**MAINE DEPARTMENT OF  
INLAND FISHERIES AND WILDLIFE**

**ADDENDUM NO. 3  
24-AUG-23**

**IMPROVEMENTS AT GRAND LAKE STREAM STATE FISH HATCHERY  
GRAND LAKE STREAM, MAINE**

BGS PROJECT NO.: 3289-14

**3 THICKENED SLAB DETAIL**  
NOT TO SCALE

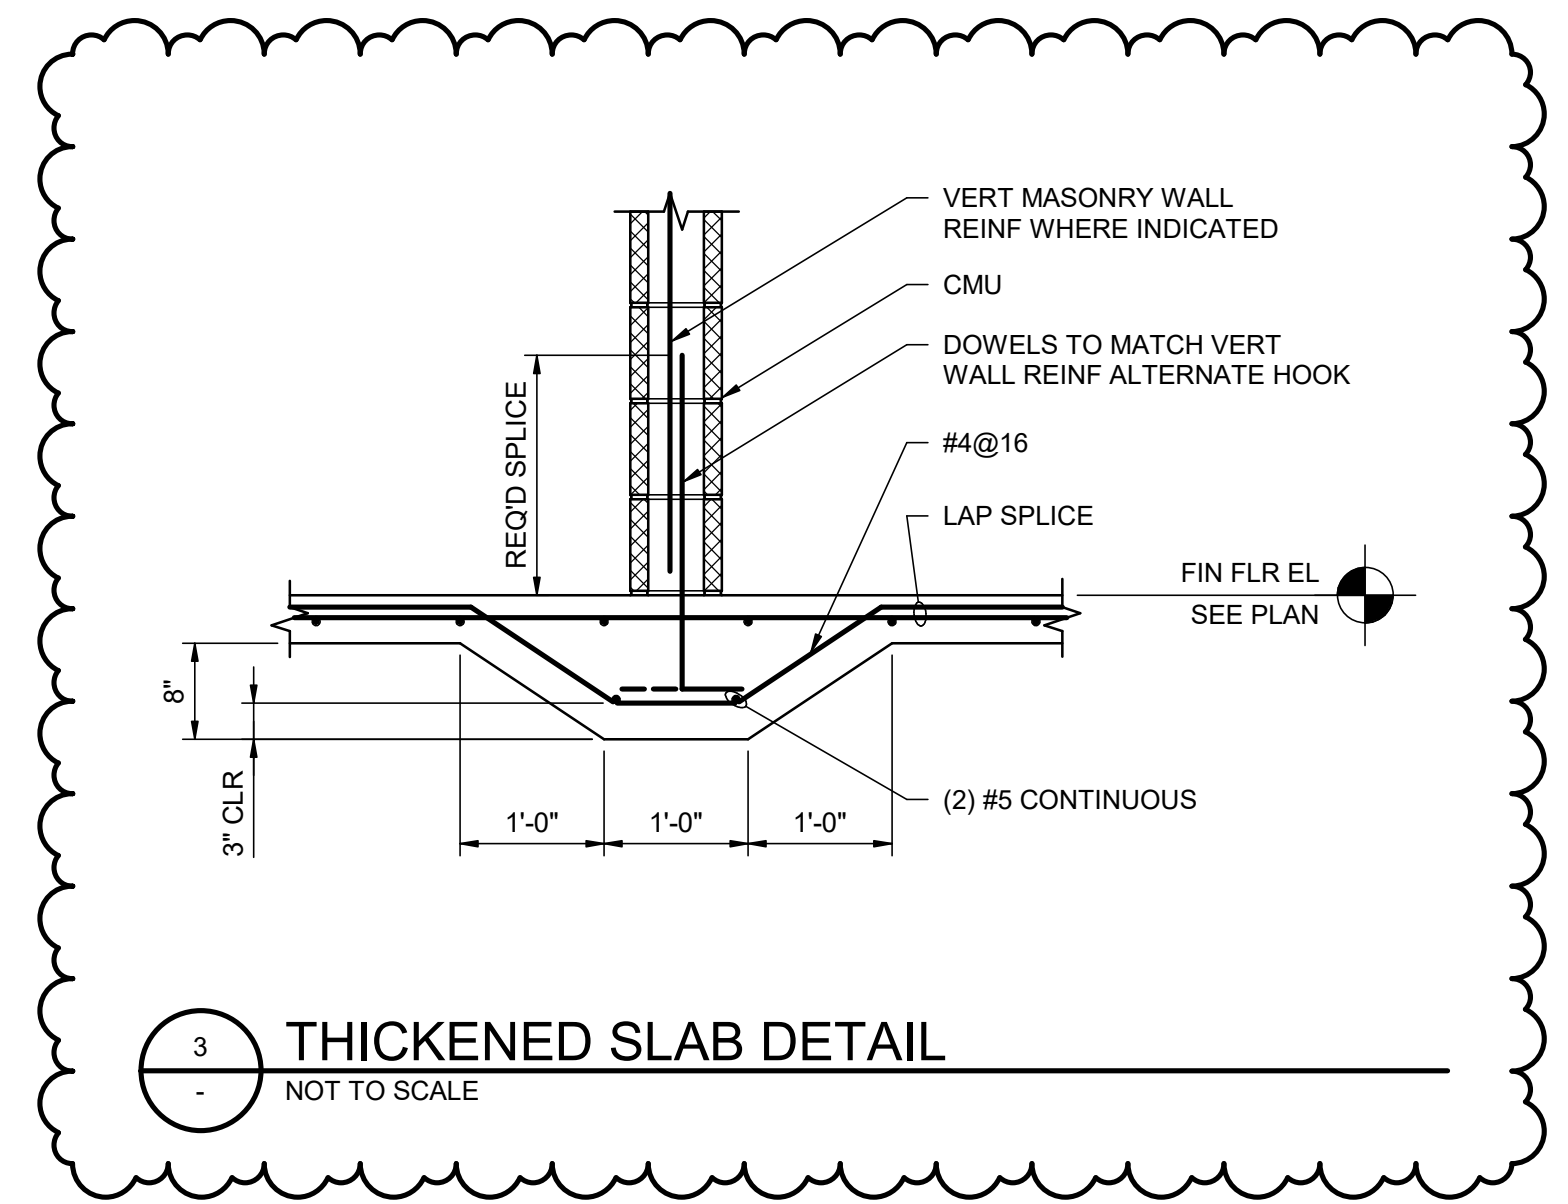
- QUESTION:** Sheet 03s-101 has a section through what I believe is a storage room labeled E/03S-301. Page 03s-301 does not exist, not in the plans or legend.

**27. SHEET 00S-103**

**ADD:** Attached detail 3/00S-103 “THICKENED SLAB DETAIL”. See updated plan sheet in this addendum.

**ANSWER:** The reference to 03S-301 is incorrect and should be 3/00S-103.
